SUBJECT: Forwards responses to NRC questions re 860402 application
 for amend to License DPR-67, revising Tech Spec limits on
 liner heat rate.

Re: St. Lucie Unit 1
Docket No. 50-335
Linear Heat Rate

RESPONSES TO THE NRC QUESTIONS
ON THE
ST. LUCIE UNIT 1 CYCLE 7, 11% SGTP
PROPOSED LINEAR HEAT RATE LICENSE AMENDMENT

a) Isolation of Steam Generator Flow

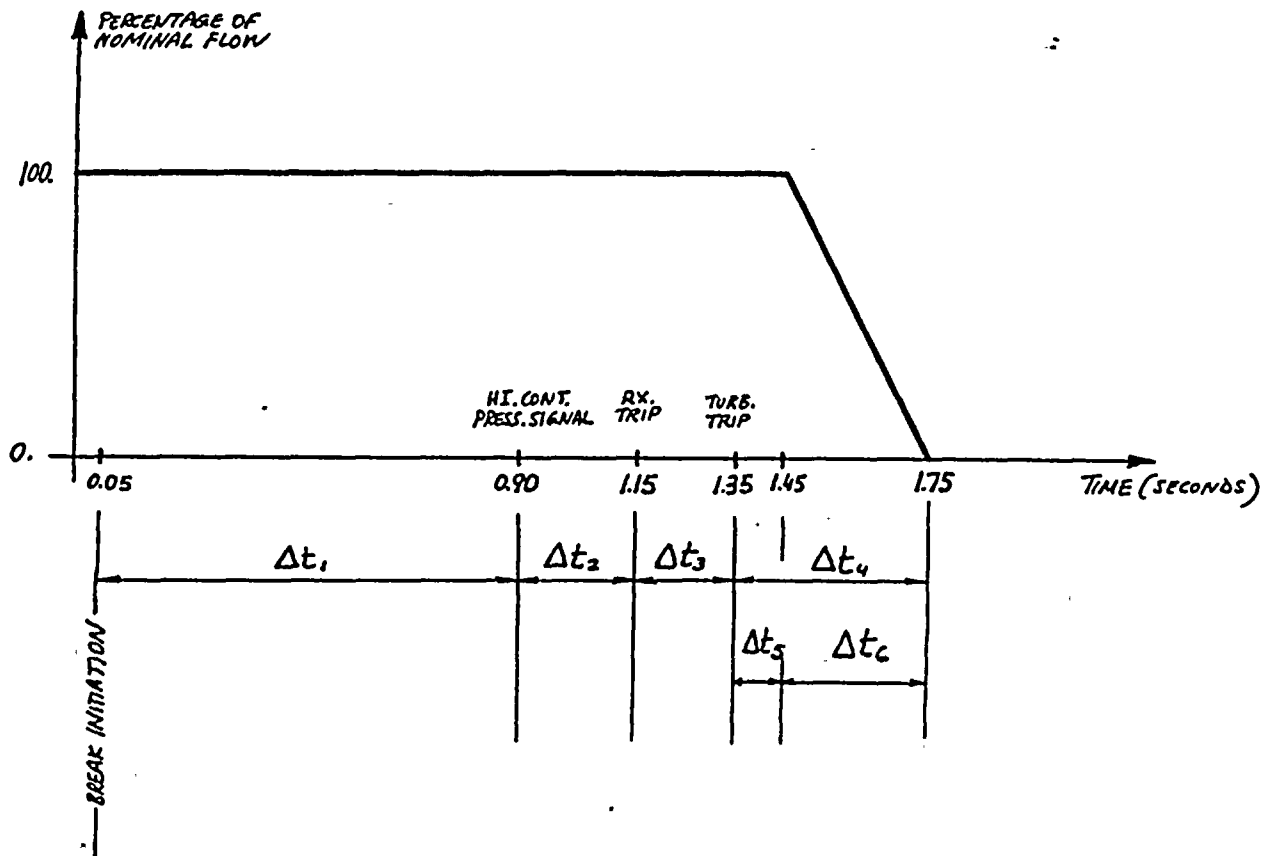
Question #4: Provide additional justification for the change in the modeling of the operation of the secondary feedwater and steam valves which allows secondary steam flow and feedwater flow after the break initiation rather than instantaneous isolation of the secondary system.

Answer: For the LOCA scenario assumed in the analysis, the steam and feedwater flows are isolated through the following logic. Immediately after break opening, a high containment pressure signal is generated. This signal produces a reactor trip signal which in turn causes a turbine trip which isolates the steam flow. The Main Steam Isolation Valves (MSIVs) are not actuated by the high containment pressure signal at St. Lucie 1. The feedwater isolation valves close on the safety injection signal. Measured closure times for these valves are in the vicinity of 60. seconds. However, flow to the steam generators will decrease more rapidly due to loss of power to the feedwater pumps and subsequent pump coastdown. Loss of off-site power is assumed concurrent with the LOCA.

The information provided below is a detailed description of the various delays and assumptions used in the isolation of the steam and feedwater flows in the LOCA analysis (see attached diagrams).

a) Isolation of Steam Generator Flow (See attached diagram)

$\Delta t_1 = 0.85$ sec. From preliminary RELAP4 blowdown analyses it can be observed that the high containment pressure setpoint of 19.7 psia is attained at 0.92 sec. A value of 0.90 sec. has been chosen here. The Δt_1 used in the analysis has been calculated as:

$\Delta t_2 = 0.25$ sec. This delay corresponds to the instrumentation response time between High Containment Pressure and Reactor Trip Signals and is based on observations of the Reactor Protective System Response Times Periodic Tests.

$\Delta t_3 = 0.20$ sec. This delay corresponds to the time between initiation of reactor trip signal and initiation of turbine trip signal and is based on observations of the plant's sequence of events recorder.

$\Delta t_4 = 0.40$ sec. This delay corresponds to the time between turbine trip signal and the signal to close the governor and throttle valves and is based on observations of the plant's sequence of events recorder (typical times range from 0.40 to 0.65 seconds).

$\Delta t_5 = 0.10$ sec. This is the delay between the signal and the time the governor and throttle valves start to close. This delay is based on information provided by the turbine manufacturer.

$\Delta t_6 = 0.30$ sec. Taken as

This delay corresponds to the time it takes for the governor and throttle valves to close. Flow through these valves during closure has been assumed to follow a linear ramp.

The above assumptions on the steam isolation conservatively represent the plant behavior in the case of a large break LOCA.
